From: Stacia Brooks
Sent: Tue Jul 20 21:20:13 2010
To: Kidd, Gavin N; 'Blue, Mike (Houston)'
Cc: Ed Lewis; Greg Childs; Julie Hoech; Leon Schwartz; Lindsay Skinner; Philip Kuentz; Susan Asel
Subject: Final Report WEST Job 3940 GSF DD II
Importance: Normal
Attachments: image001.png; BOP Final 3940 GSF DD II.pdf; Rec Sum 3940 GSF Dev Driller II rev2.xls

Subject: *GSF Development Driller II*
Reference: Acceptance of Well Control Equipment

Enclosed is the report from our recent assessment of the well control equipment on the *GSF Development Driller II*. Thank you for using WEST Engineering Services to assist in performance of the well control equipment inspection and acceptance testing.

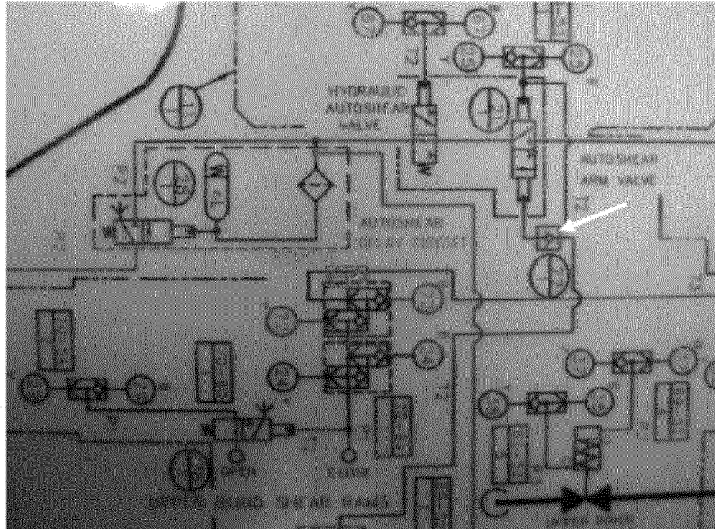
Figure 12.01: shows part of the auto shear circuit hydraulic schematic. The arrow indicates the POCV which is included in the circuit to keep a positive 'arm' pressure on the autoshear arm valve, when the pilot pressure to the 'arm' side of the valve is lost, i.e. in a dead man/auto shear situation. From testing with hotlines to the pilot side of the 'arm' valve it was proved that if the POCV should leak and release the positive 'arm' pressure to the valve, the arm valve will begin to close and 'chatter', thus preventing correct operation of the auto shear system.

Attachment A

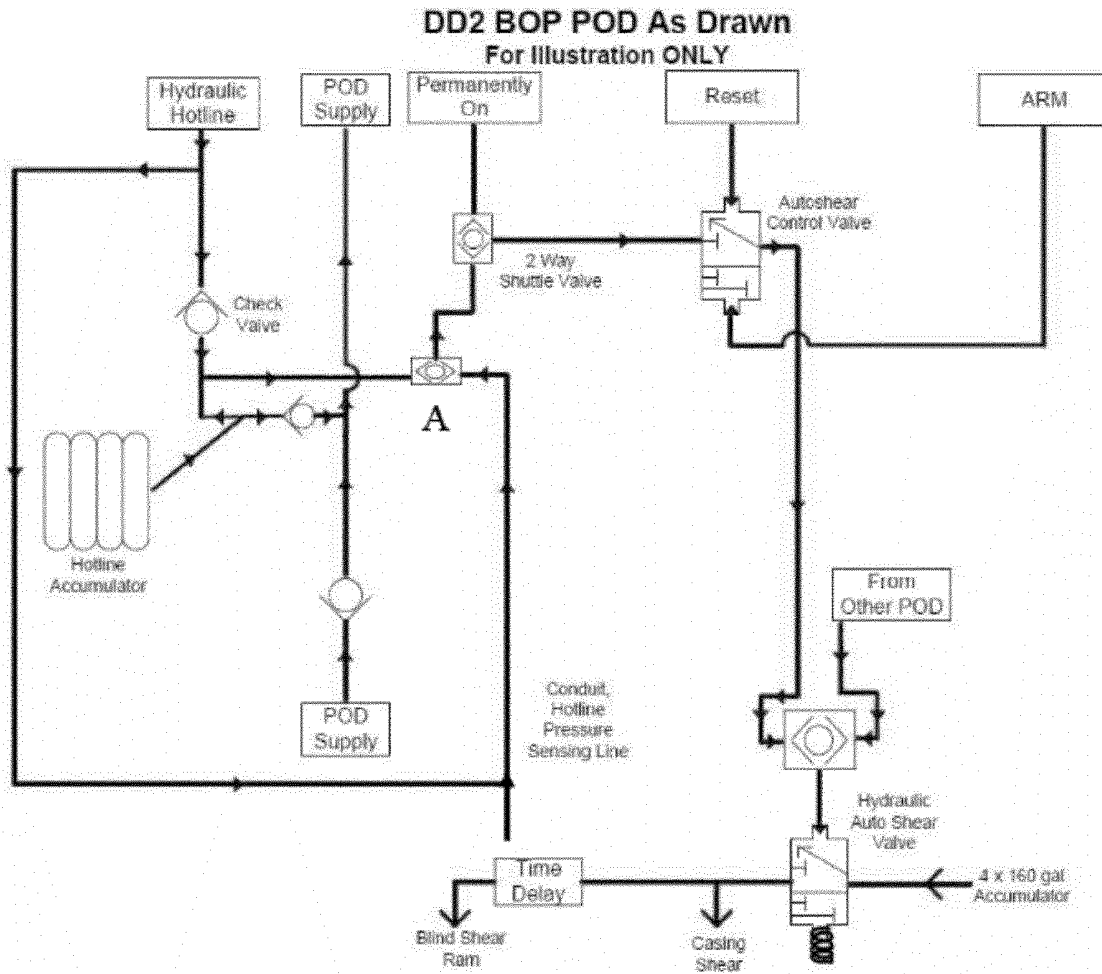
Attachment A shows the as built hydraulic schematic of the pods. Because of the position of the hotline pressure sensing take off below the check valve in the hotline supply, to shuttle valve A it would be impossible for the pilot pressure to the hydraulic auto shear valve to bleed off, due to the check valves in the system, accumulators etc, and activate the dead man sequence in case of a catastrophic failure of the riser system and loss of all hydraulic and electrical supplies.

Attachment B

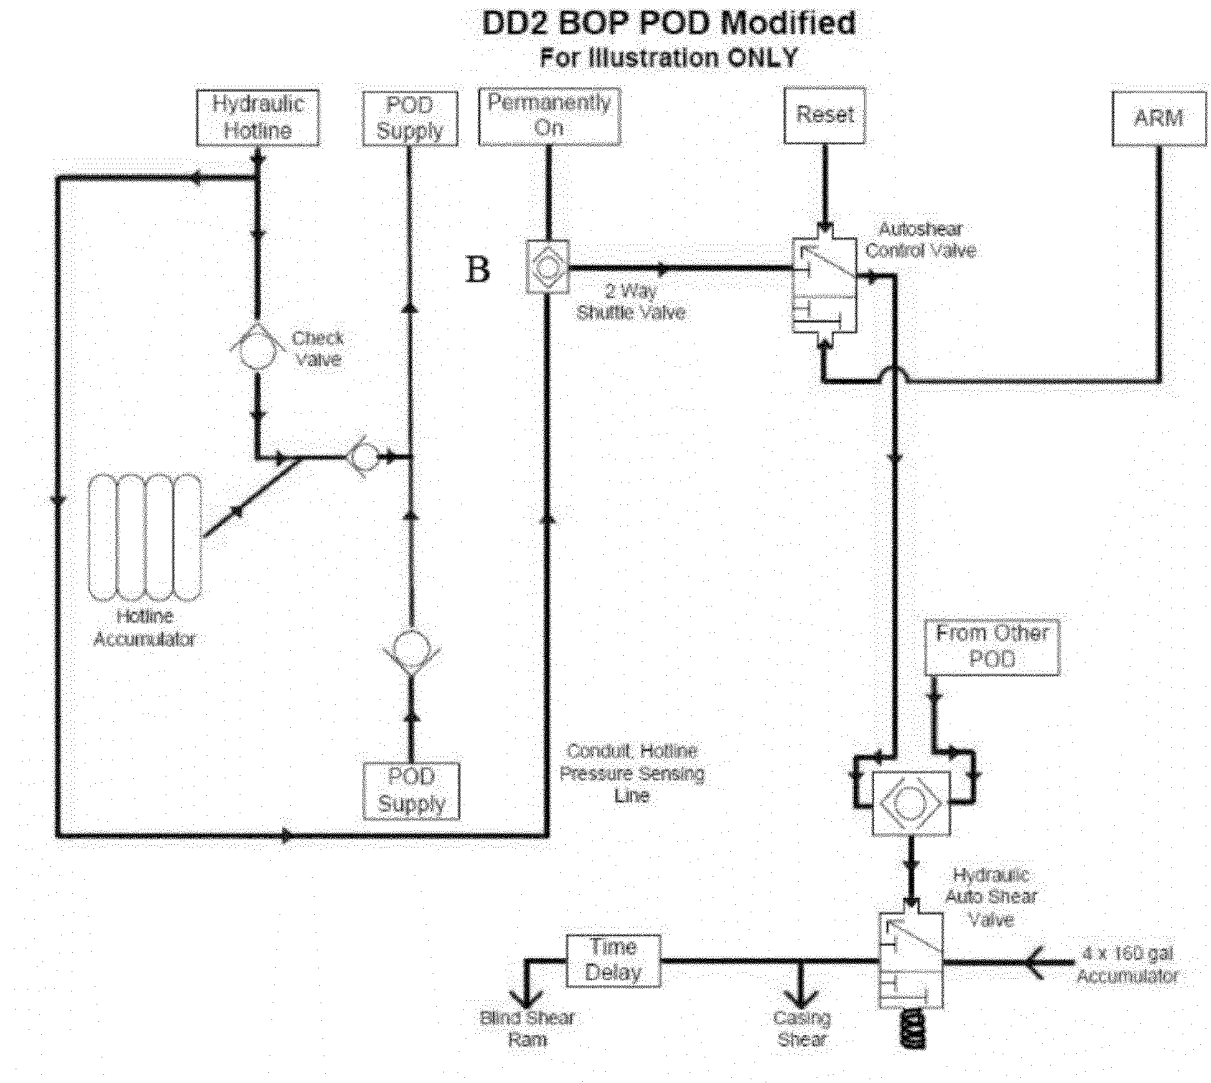
Attachment B shows the hydraulic schematic after removal of shuttle valve A and attachment of the pressure sensing line directly into shuttle valve B. This will allow the system to operate as designed. The system was proved to function correctly after this modification.

Figure 17.01: Upper annular cap seal, also see Figure 17.02, being tested using a TAM packer before the BOP is run. This is one method of testing this seal during stump testing. The flex joint and flange connection to the upper annular are also tested using this method.

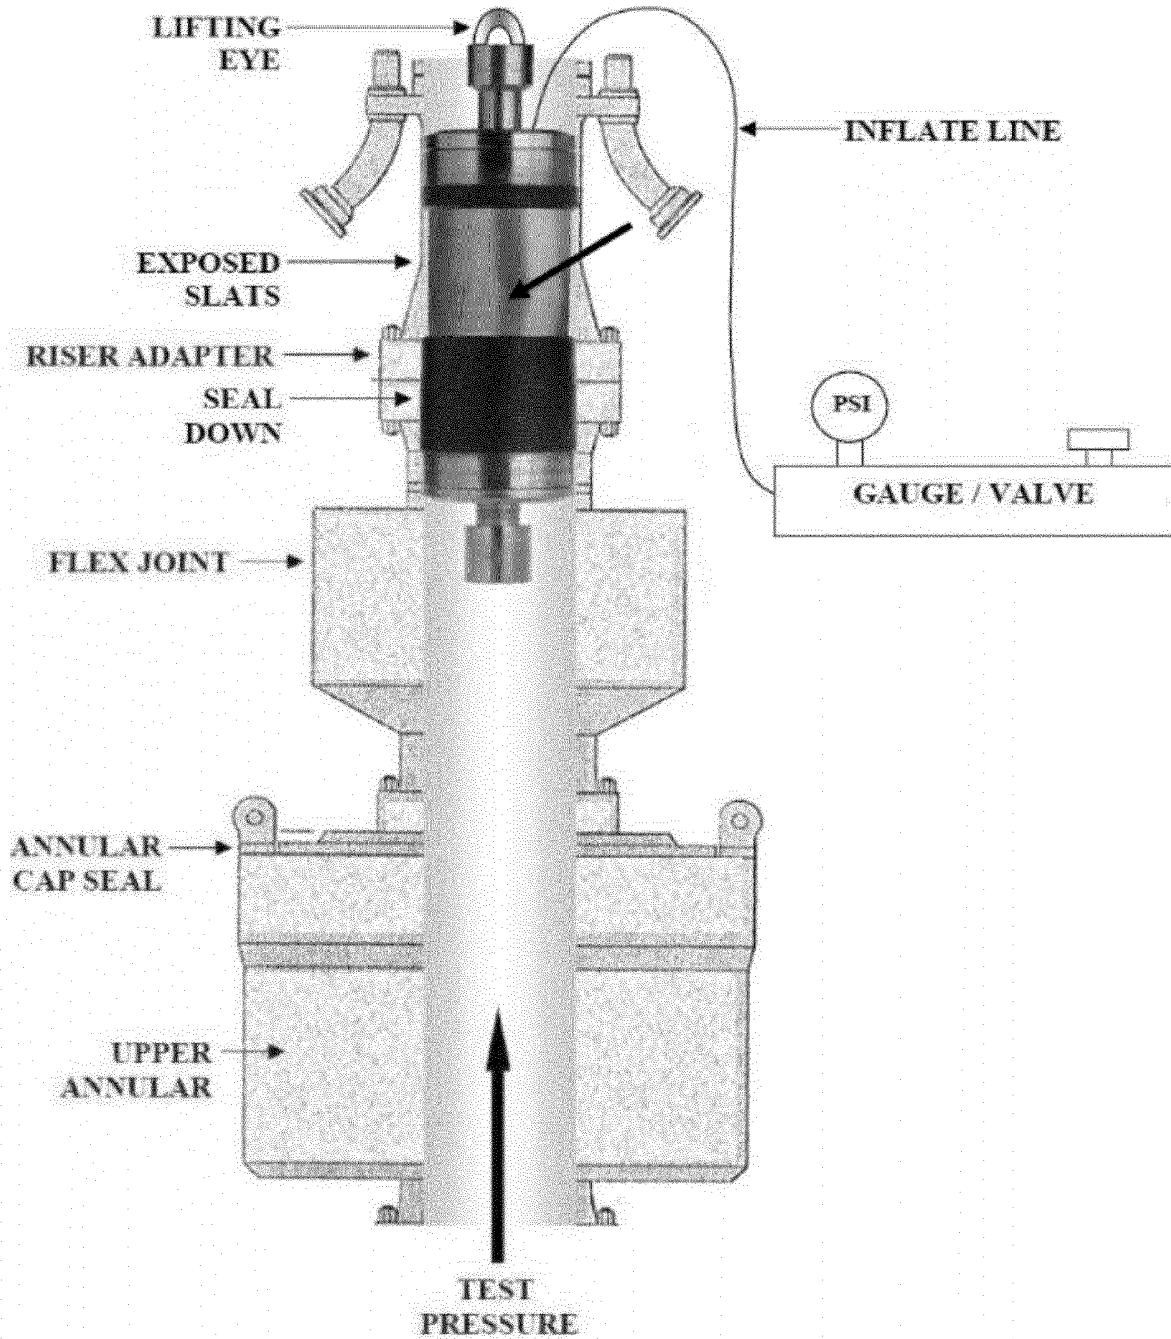
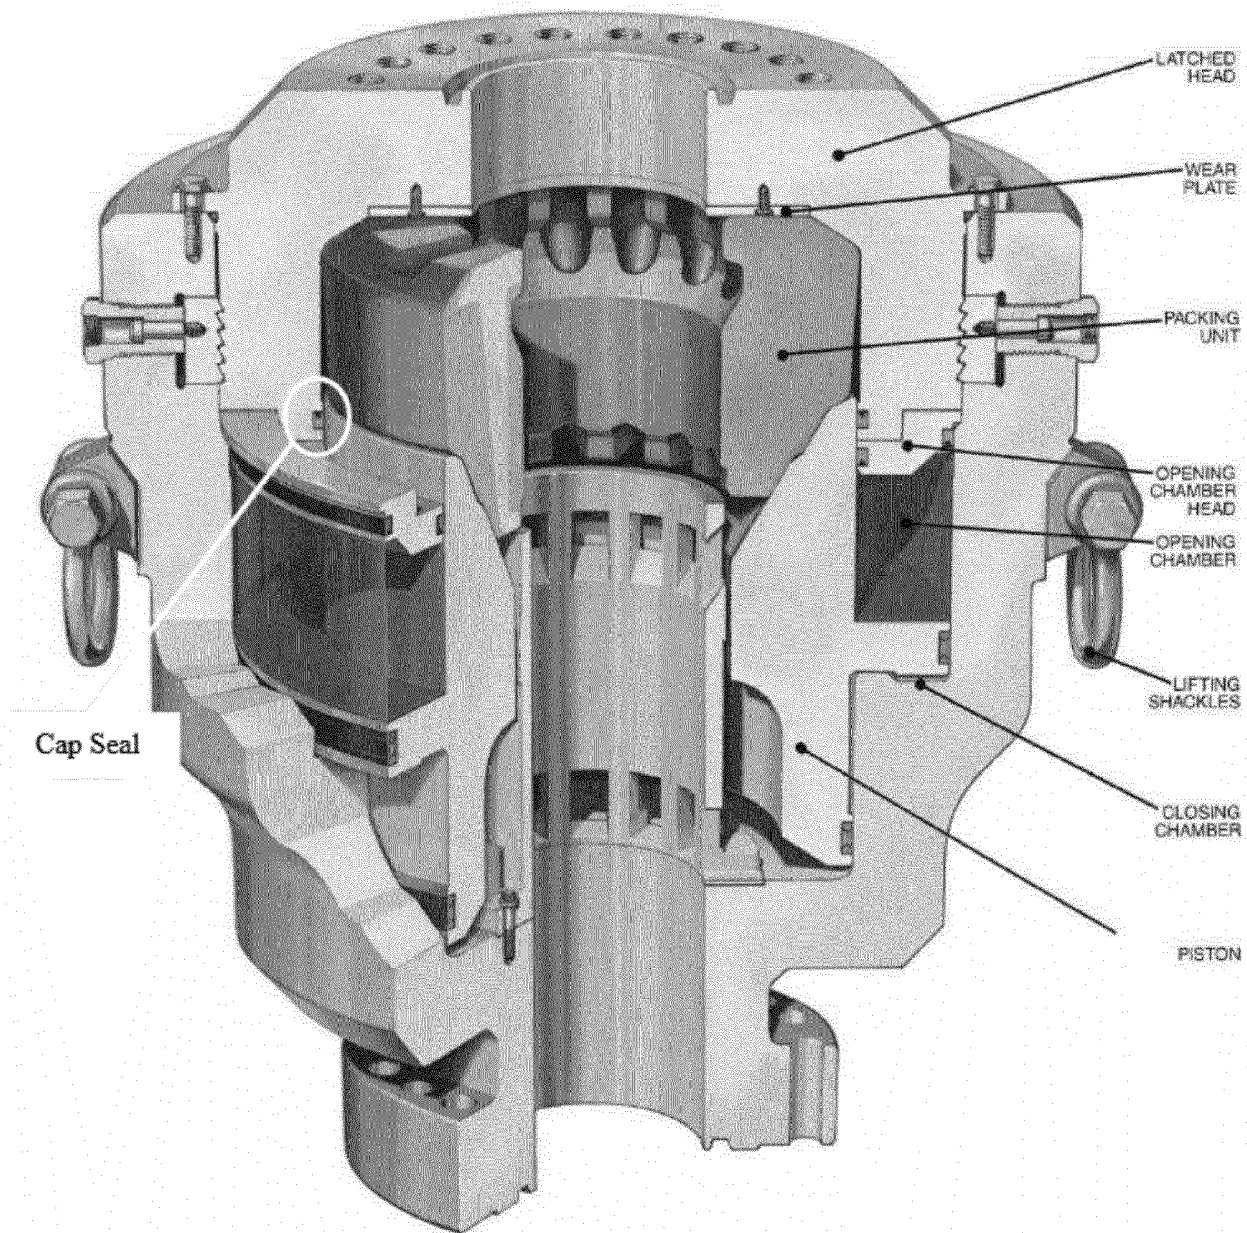
If the seal were to leak subsea, the only option would be to retrieve the LMRP to surface to affect a repair. See Figure 17.01 and 17.02 below.

Figure 18.01: This shows a typical MUX pod with ROV observable analogue gauges fitted for all critical functions

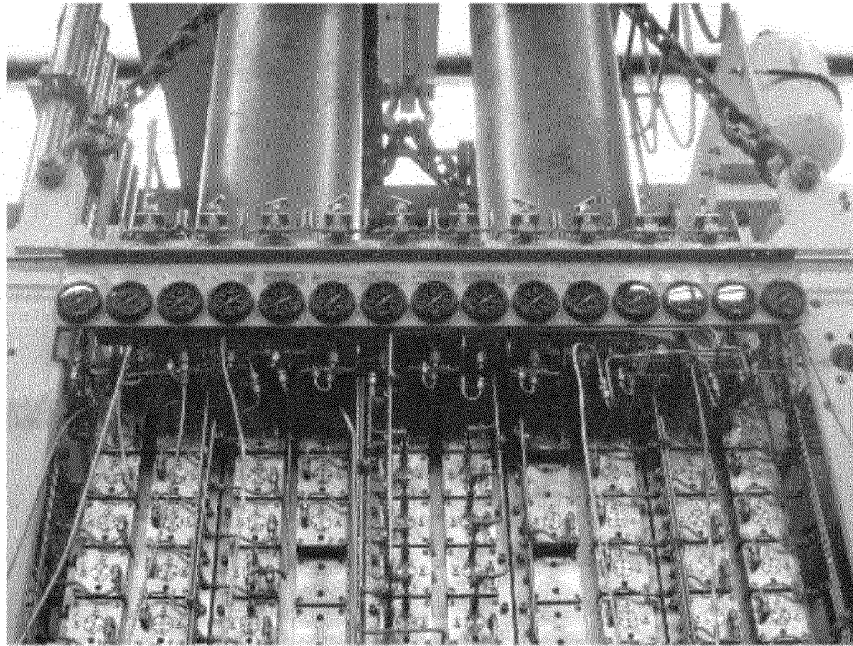
With reference to recommendation #3, the Hydril Controls MUX control pod relies solely on electrical pressure transducers to monitor the critical operating pressures within the pod. If any of these transducers were to fail subsea, there is no way of monitoring the pressures within the pod. Analogue gauges on the pod would allow the ROV to monitor critical pressures and ensure the pod was functioning correctly. This could avoid the need to pull the LMRP to effect repairs to the pod. See Figure 18.01, below.
